PRODUCT CHANGE NOTICE PCN Form (D4-E000-73)

PCN#15-073

Surface Mount Series

Change of internal production device marking for space limited products affecting FORM.

Illustration of “Old” vs. “New” Marking

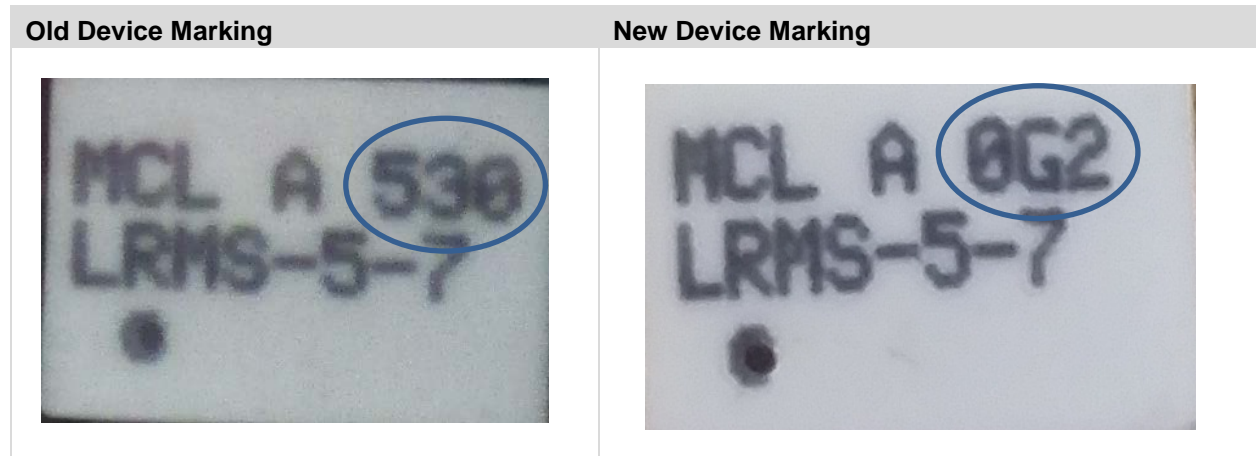
Internal production coding change to enable enhanced traceability on space limited products. This does not change the Mini-Circuits policy on date codes as per http://www.minicircuits.com/pdfs/tape_reel.pdf
